SERVICE BULLETIN

MODEL RB398/518/218	Aug 2016 Serial: from 164*****
--	---

SUBJECT: Parts Change (Planet Cage Unit)

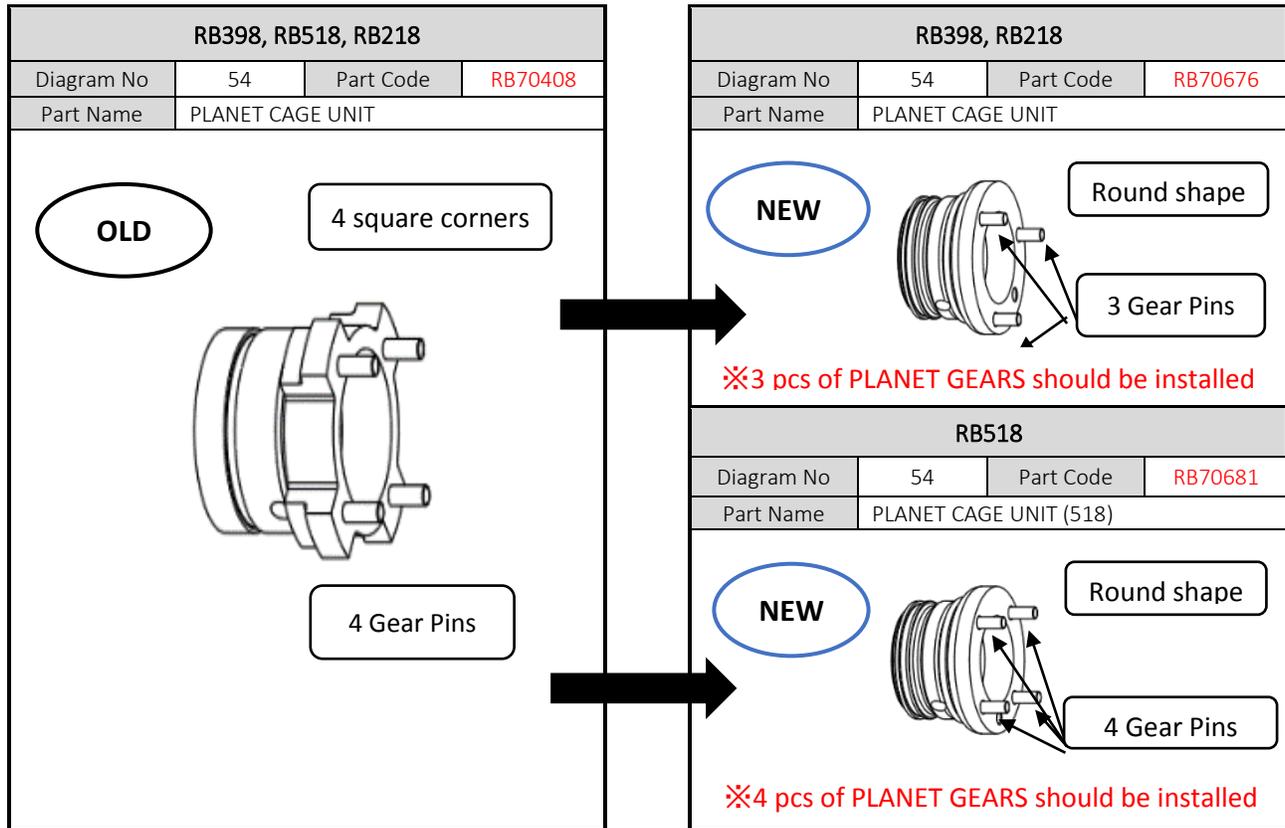
Below parts has been modified. Performance & durability of tools are same as previous version.

- New planet cage unit is different between RB398/218 and RB518. Please do not assemble the new PLANET CAGE UNIT for RB398/RB218 into RB518. It may cause malfunction.
- PLANET GEAR (RB10341) has not been changed.

OLD Version		New Version	
Diagram#	Part#	Description	Parts Supply	Part#	Description
54	RB70408	PLANET CAGE UNIT	While supply lasts	RB70676	PLANET CAGE UNIT
				RB70681	PLANET CAGE UNIT (518)
Interchangeability; YES
